UNITED STATES ENVIRONMENTAL PROTECTION AGENCY REGION IX – PACIFIC SOUTHWEST REGION 75 Hawthorne Street San Francisco, CA 94105-3901

Re: August 16, 2011 Clean Water Act Inspection

Industrial User Inspection Report

Industrial User: Pyramid Circuits

Photo 5
Scrub machine – view showing water bin Taken by Anna Yen on August 16, 2011

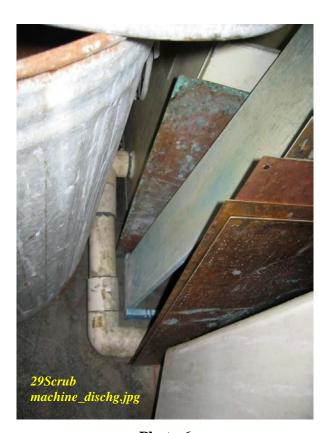
After electroless plating of copper, for example, to plate the newly-drilled holes on the panels, the panels are sent through a machine called a scrubber. This machine has rotating brushes that clean off the panel. Water is used in this process. The used water collects in a bin, which is piped to the onsite wastewater treatment system. *See Photos 4-6 in Attachment 1*.
